Re: Proposed Changes to Biglow Canyon Wind Farm: Request for Department of Energy Determination Pursuant to OAR 345-027-0050(5)

AMENDMENT III ARCHAEOLOGICAL SURVEY REPORT BIGLOW CANYON WIND FARM SHERMAN COUNTY, OREGON

Biglow Canyon Wind Farm – Supplemental Wetlands and Waters Determination and Rare Plant Habitat Survey for Amendment III

Re: Biglow Canyon Wind Farm Change Request #3 Modification of micrositing corridors

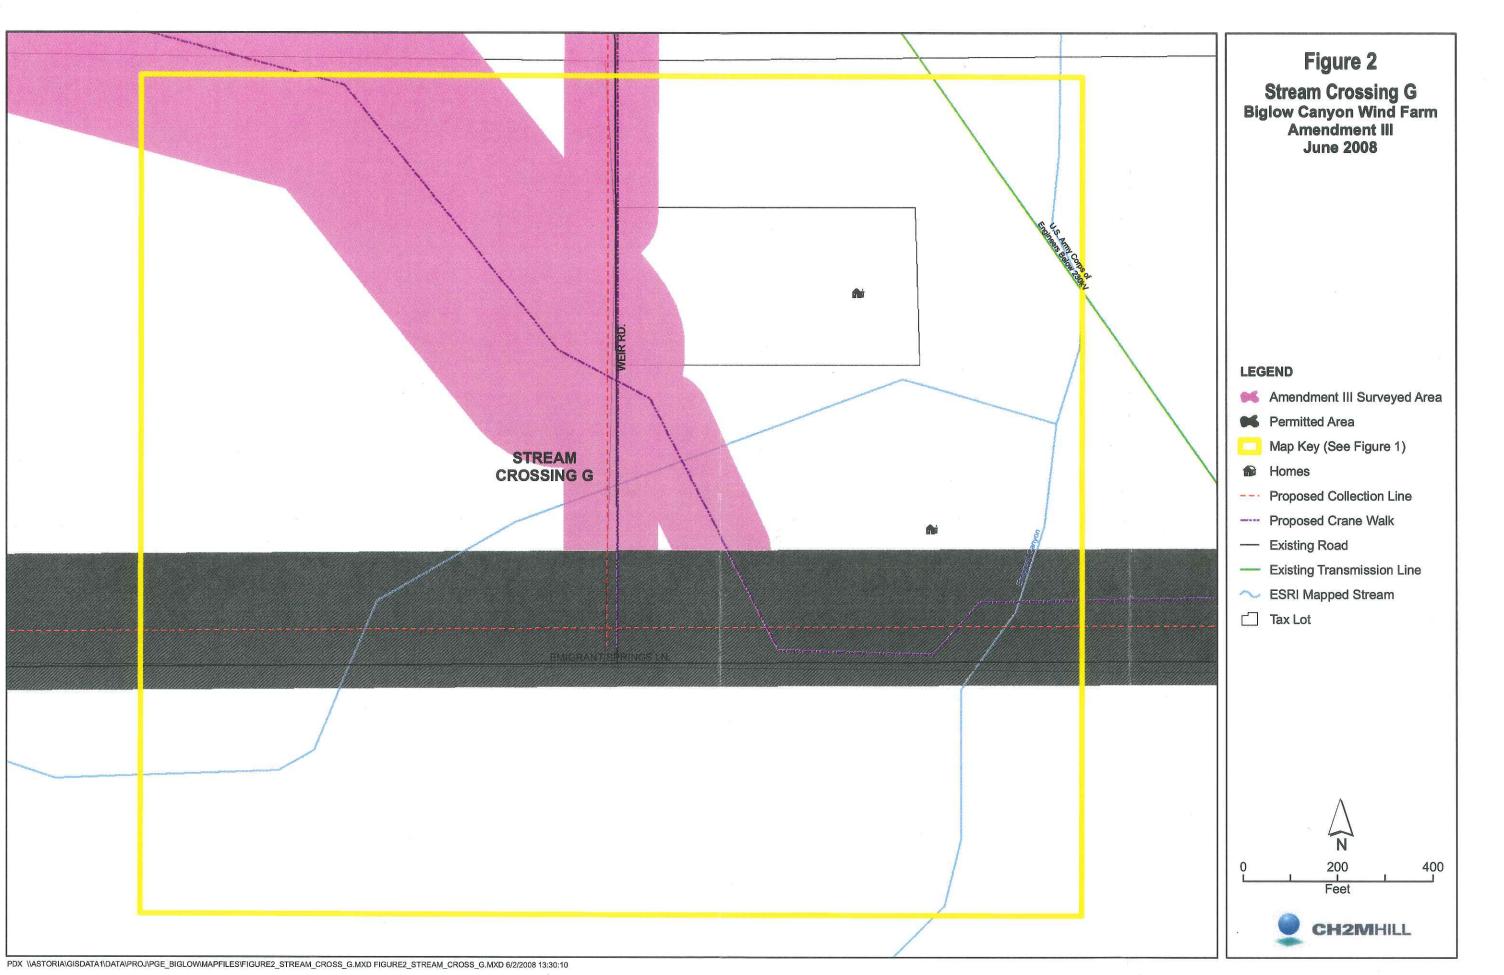
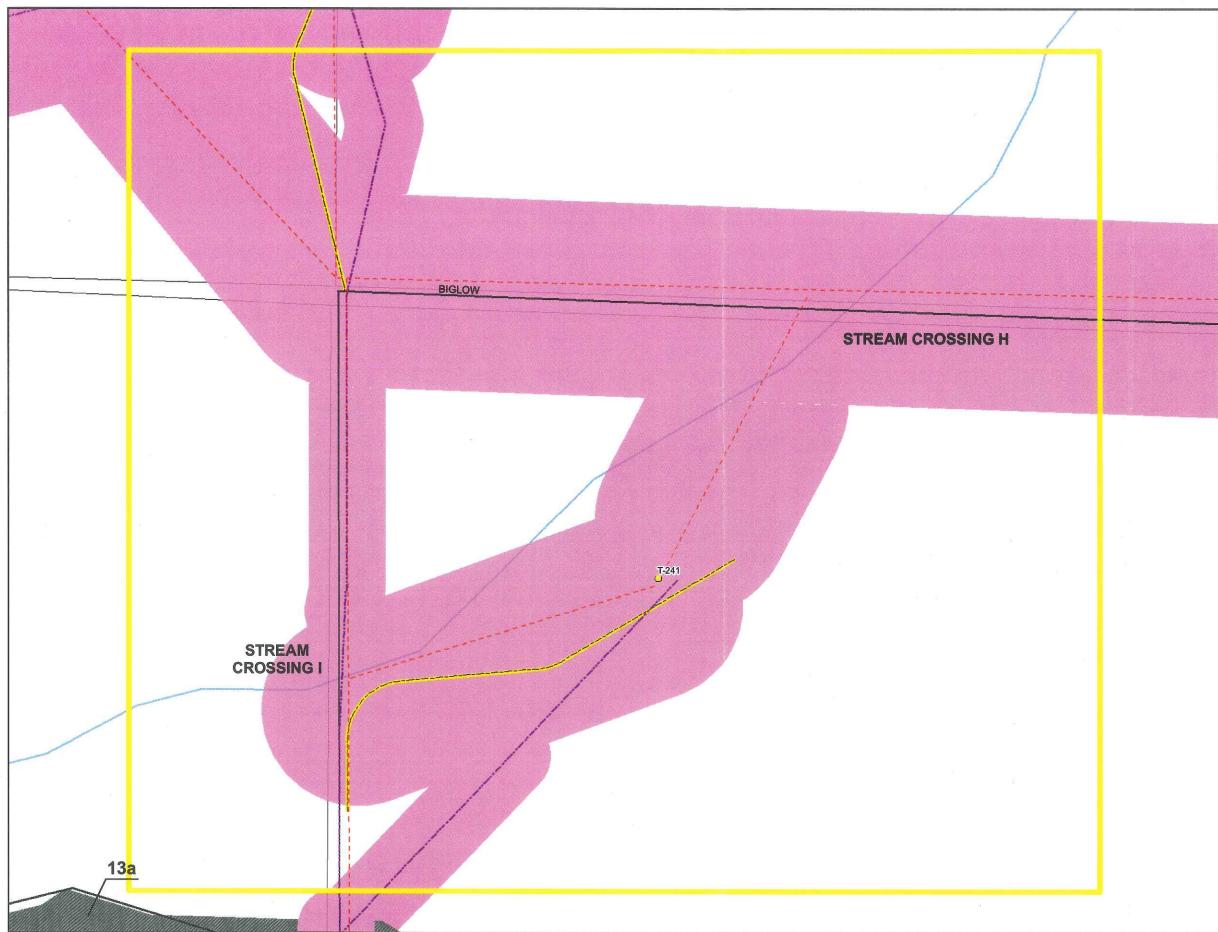
The purpose of this determination was to investigate additional modifications to the June 2007 Facility layout (Change Request No. 2) and to satisfy the site certificate Condition 55 criterion of performing a spring survey for rare plant species. CH2M HILL conducted site visits on March 31, 2008, and May 5, 2008, to determine the presence and extent of wetlands or jurisdictional waters, as defined under Section 404 of the Clean Water Act and the Oregon Removal-Fill Law. Suitable habitat for and presence of federal and state listed plant species were also investigated. Study areas G, H, I, J, and K were investigated for the potential presence of federal and state-listed plant species. Study areas G, H, I, J, and K were also investigated for the presence of potentially jurisdictional wetlands and waters. Figure 1 shows the study area locations.

No jurisdictional wetlands were identified within the study areas. Potentially jurisdictional waters were identified at study areas G, H, and I (see Figure 1). All three drainages are considered ephemeral streams. The potentially jurisdictional waters identified at these drainages may be affected by construction activities.

The facilities map provided by PGE indicated potentially jurisdictional waters within the boundary at study areas G, H, I, J, and K (Figure 1).
